BOARD ACTION REPORT – APPEALABLE ITEM

Project Name: 231 Venetian Drive

Request: Certificate of Appropriateness and Variance requests associated with the construction of a one-story 544 square foot garage addition and swimming pool to a one-story contributing residence.

HISTORIC PRESERVATION BOARD MEMORANDUM

13022
SP1

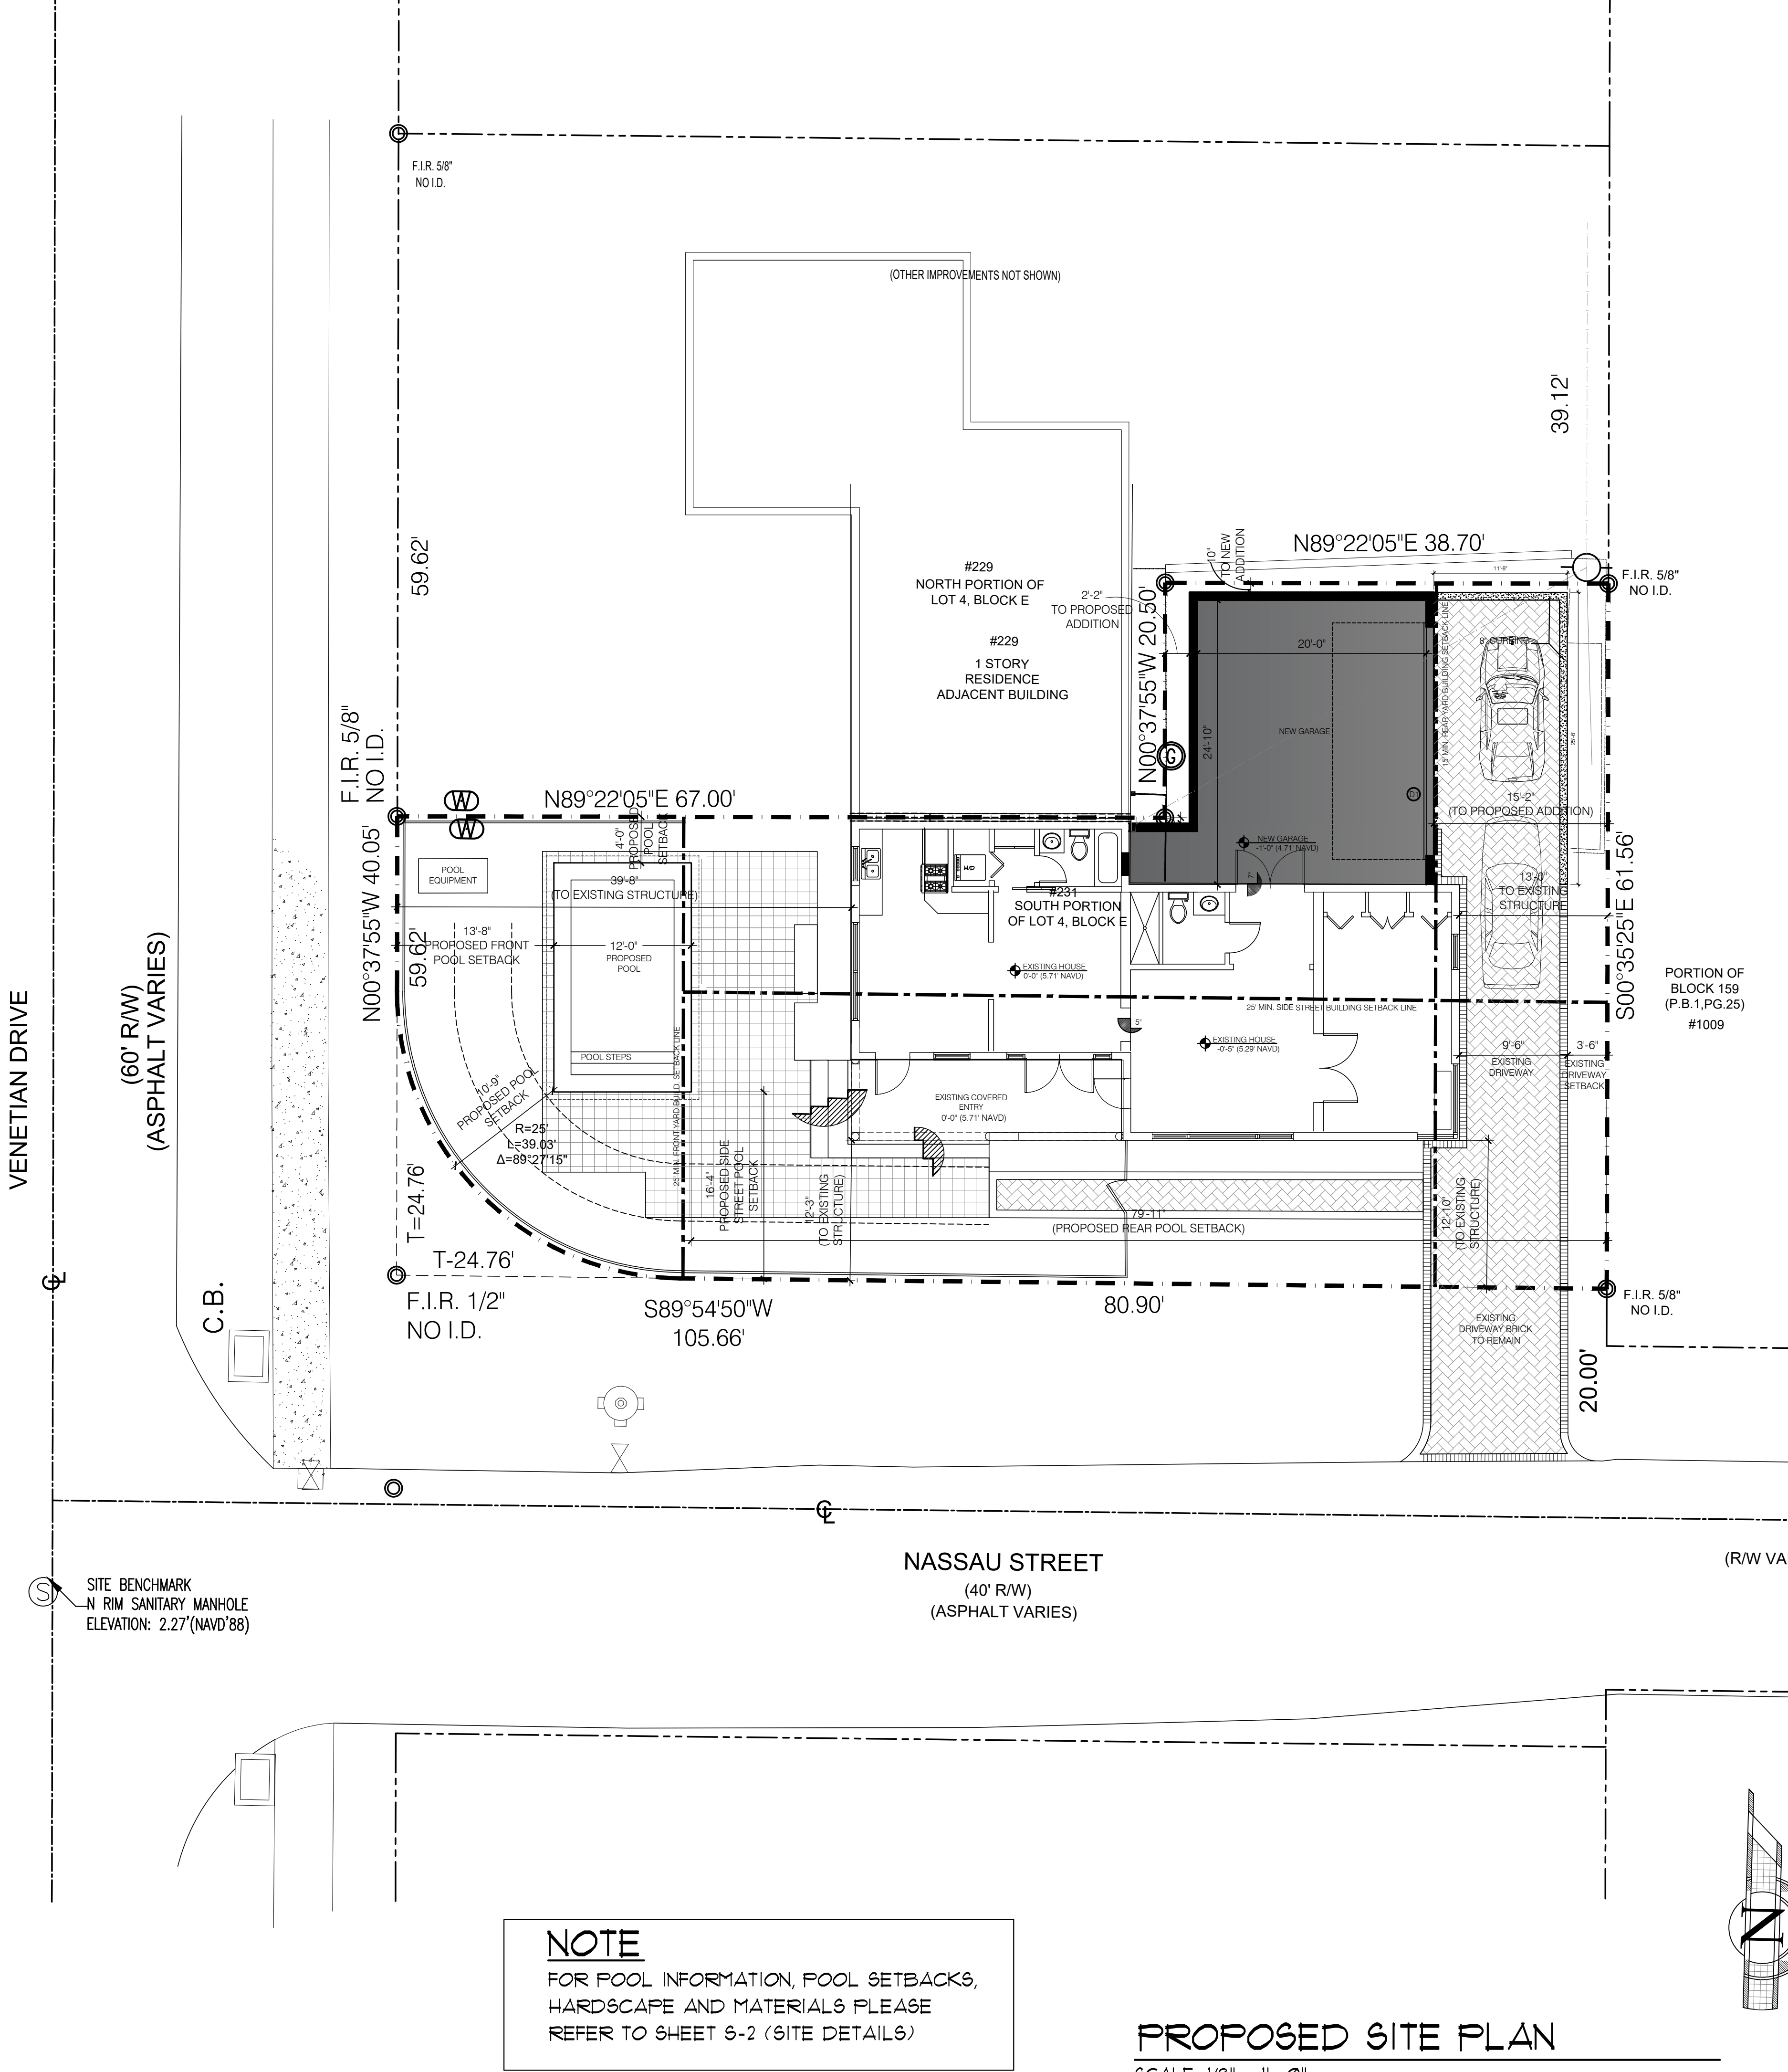
1. That all measurements including size, height, and setbacks for the proposed pool equipment be included on the site plan and associated plan sheets.
2. That the required and proposed setbacks be provided in the site data table for the proposed pool setbacks per the approved variance and as required listed in LDR Section 4.6.15.
3. Provide a sidewalk in-lieu fee.
4. That the scale of plan sheet "SP" be revised to be the same scale as the survey (1" = 10' scale).

SP7

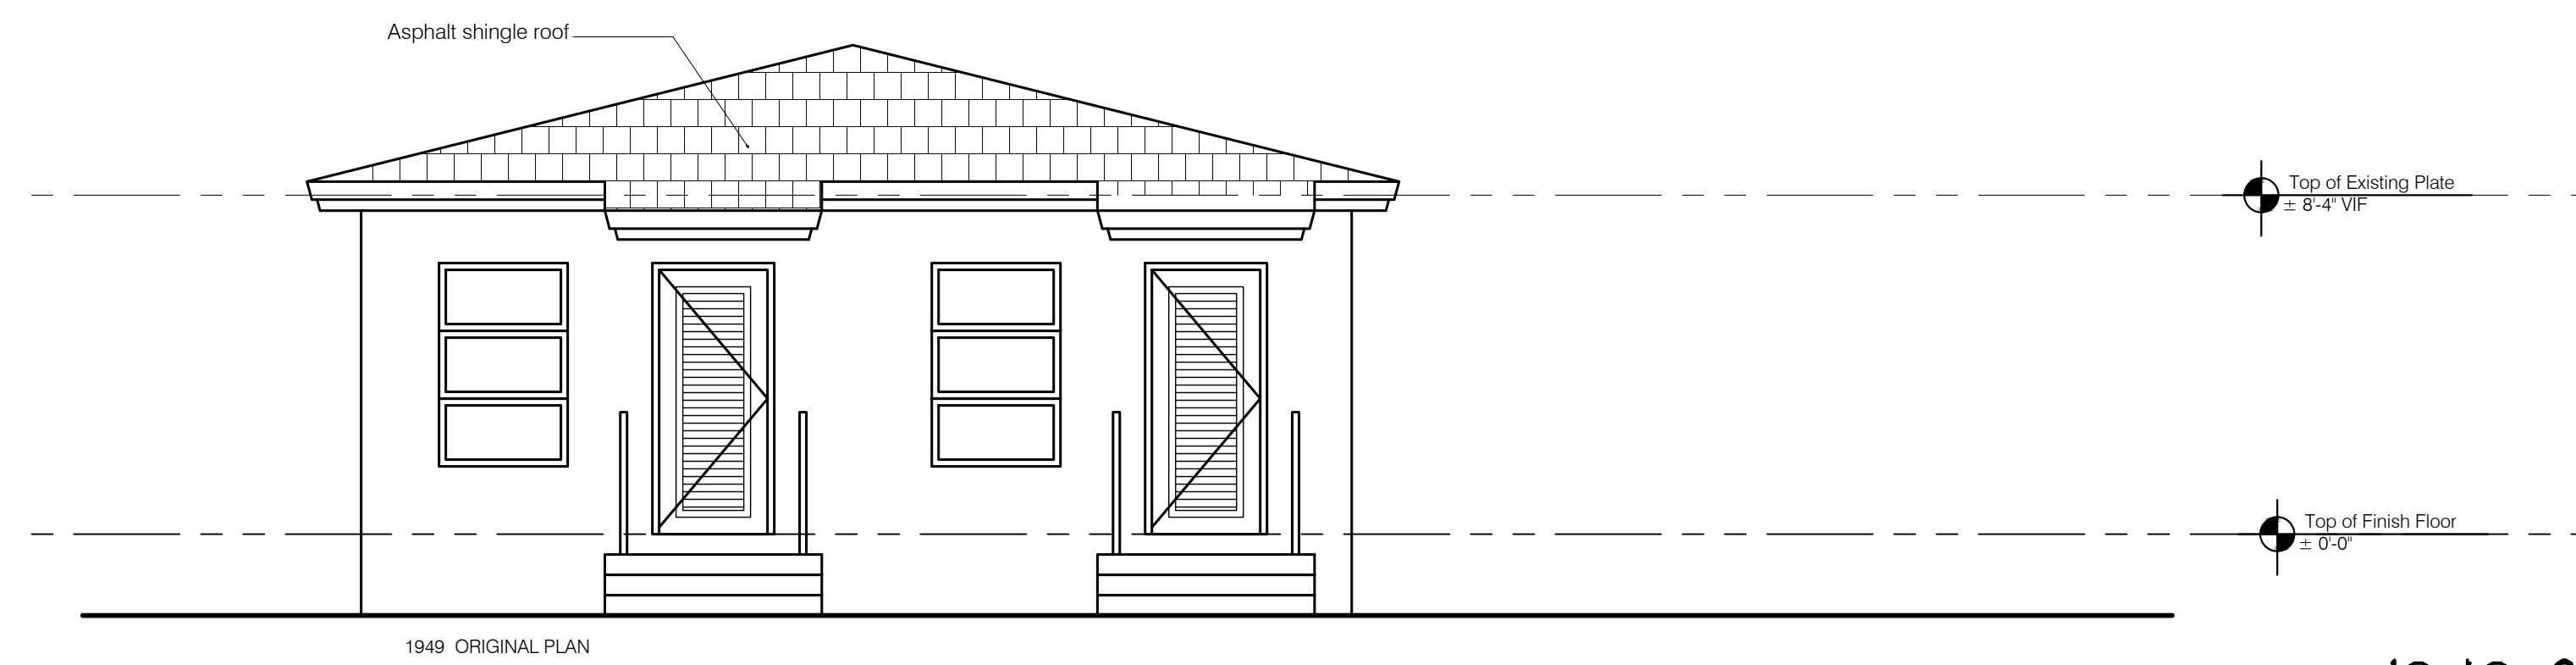
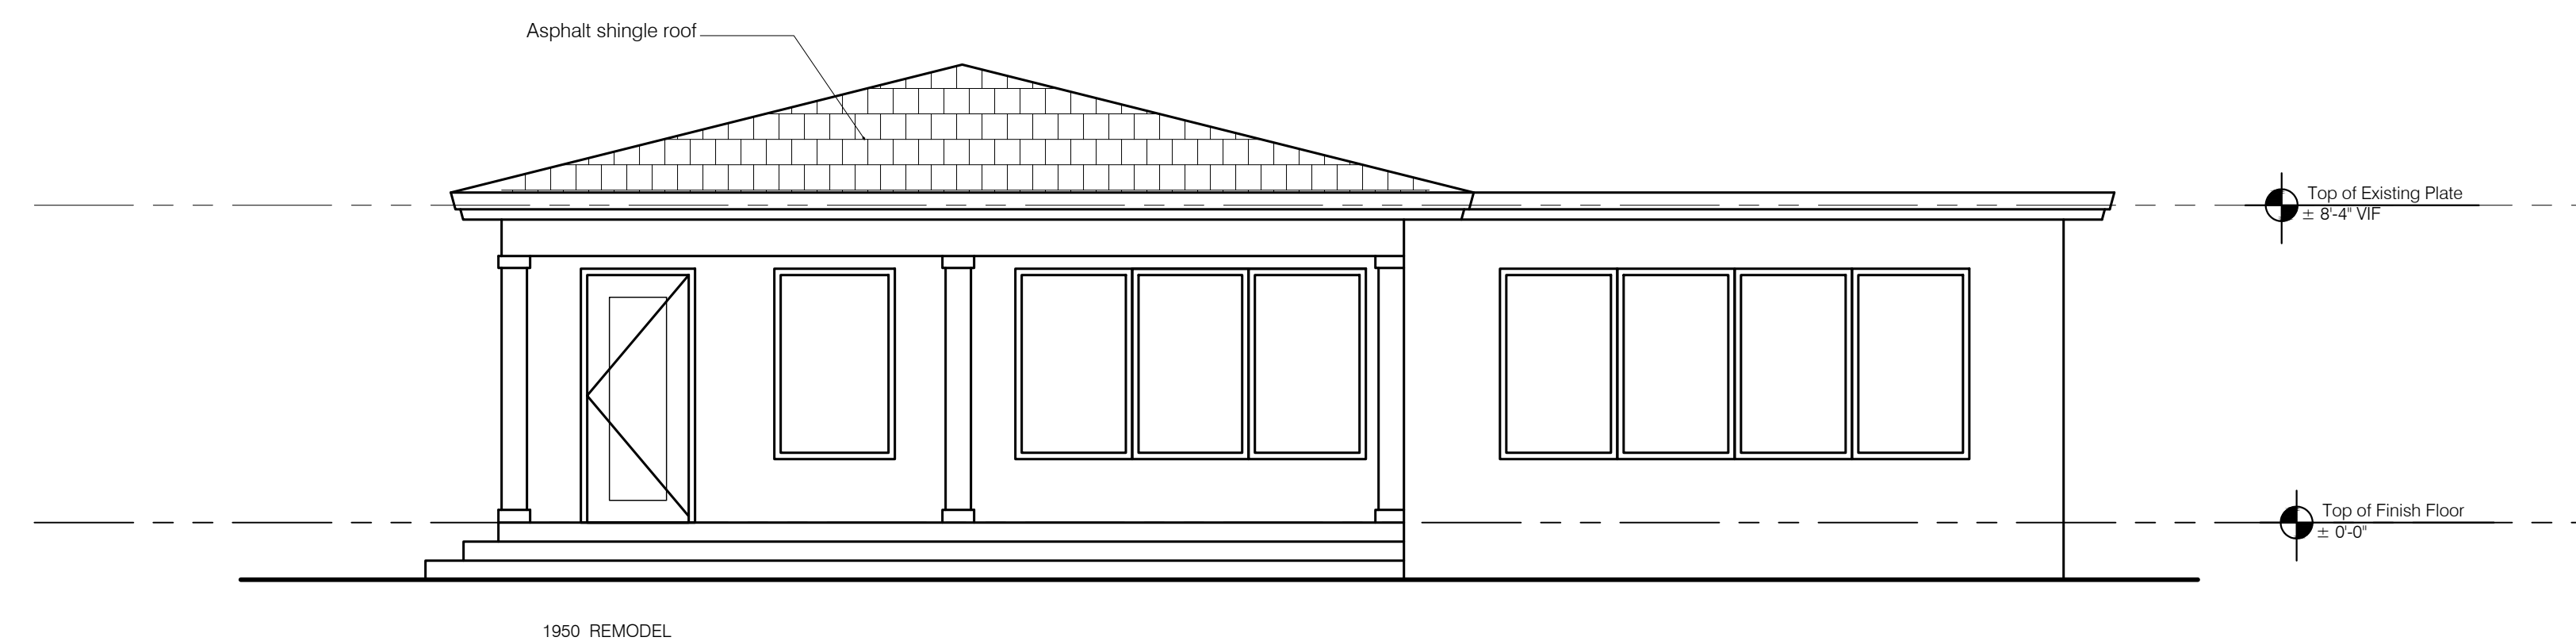
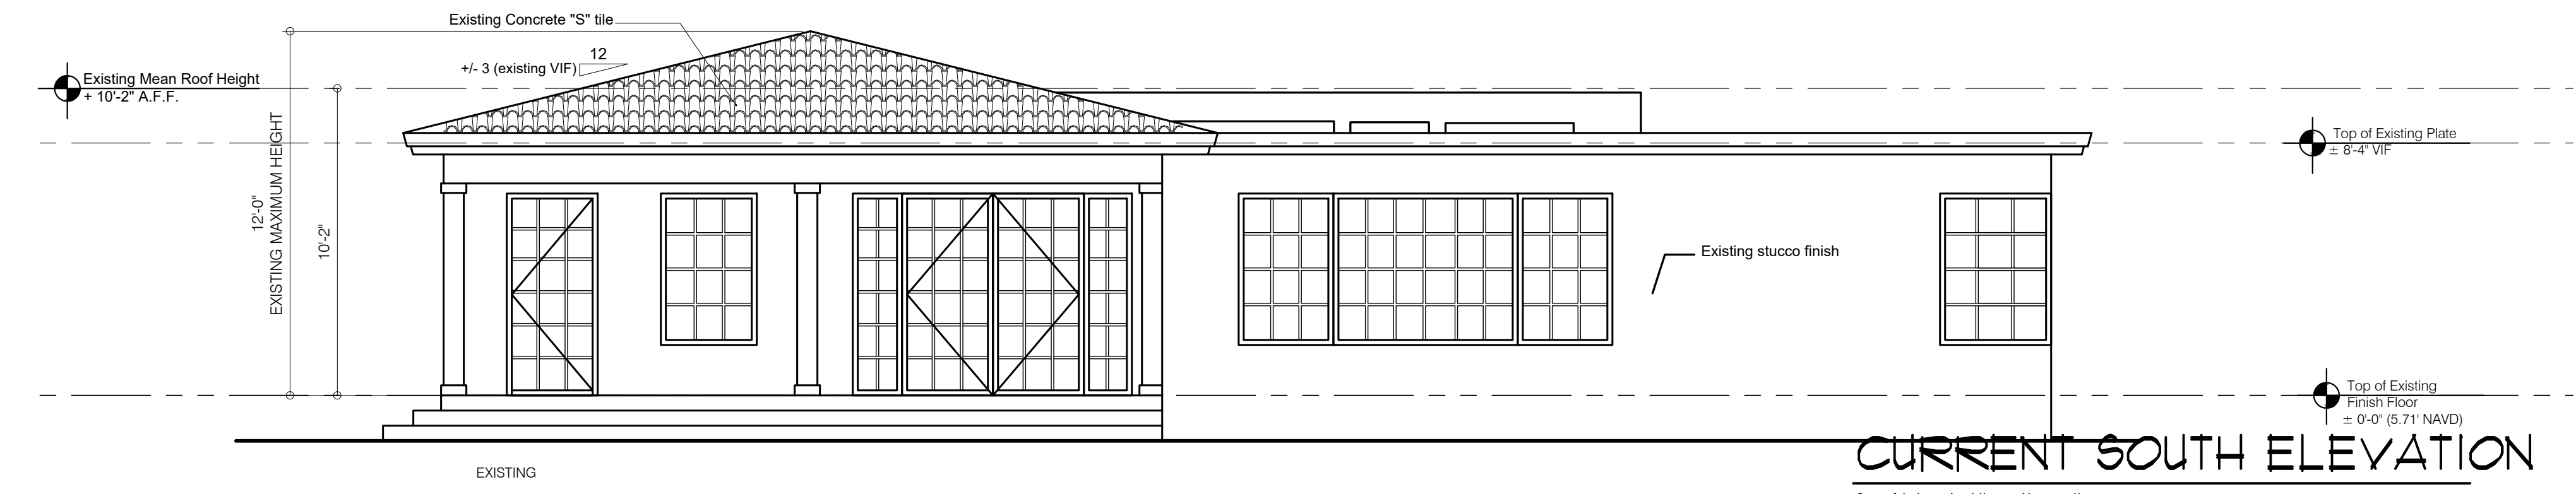
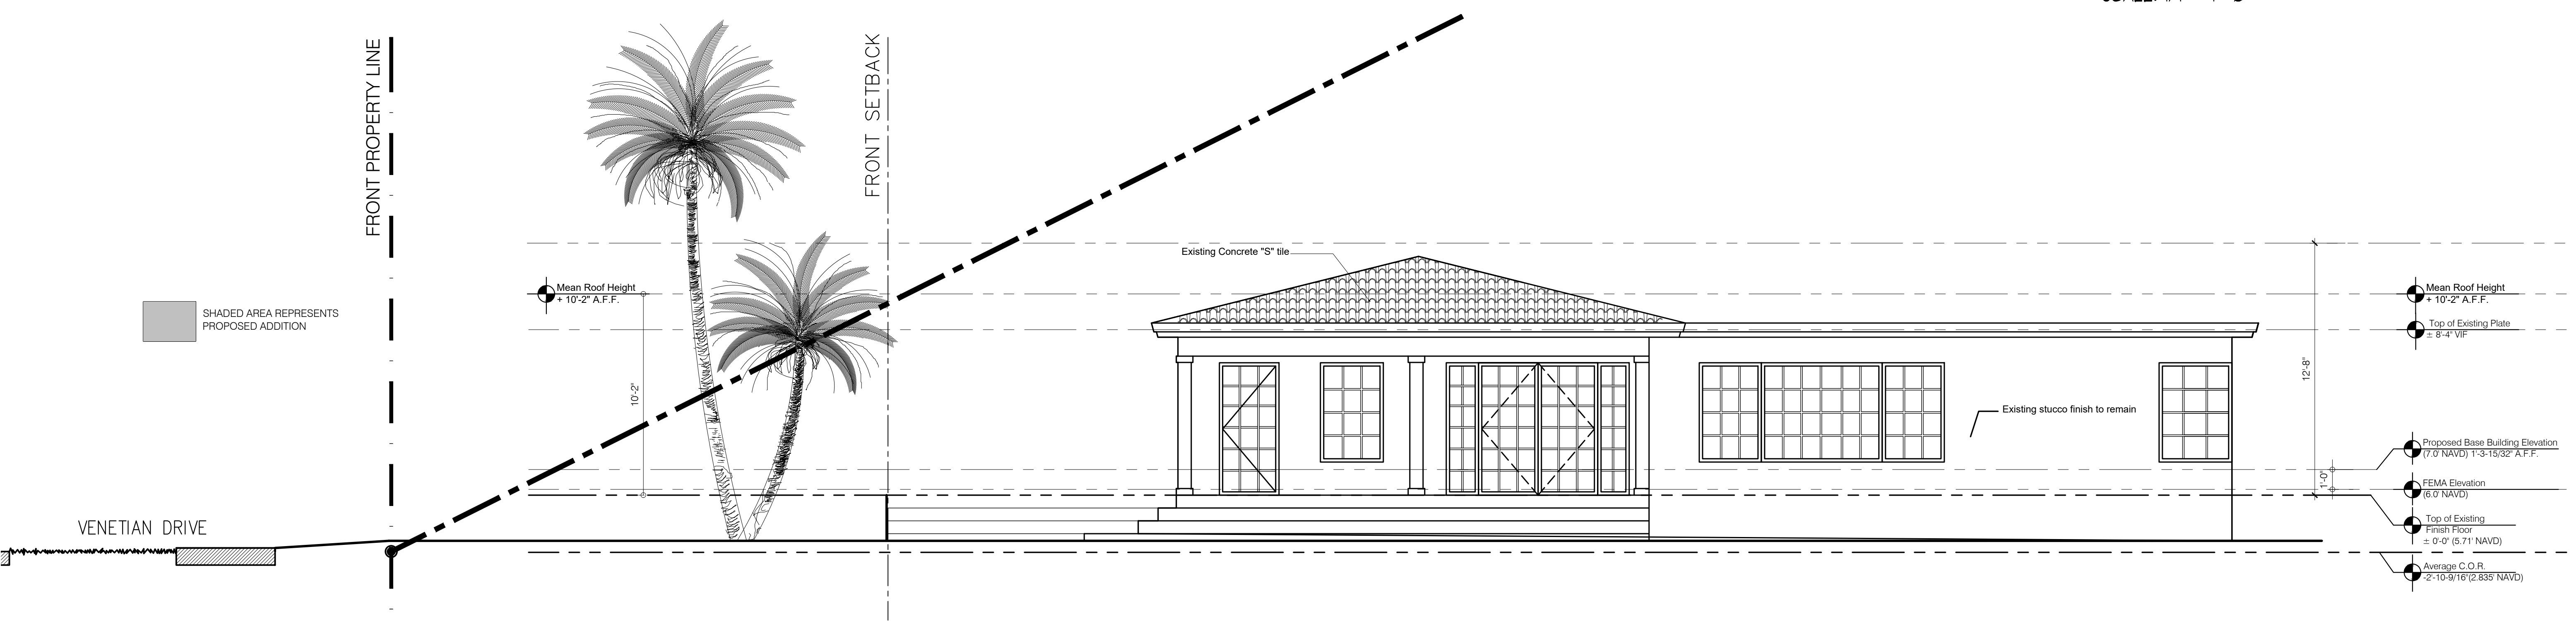
- Proposed addition complies under the 2:1 height plane ratio as illustrated on sheet SP-7.
 - d. See illustration below: [Amd. Ord. 38-07 2/5/08]
 - Complies.
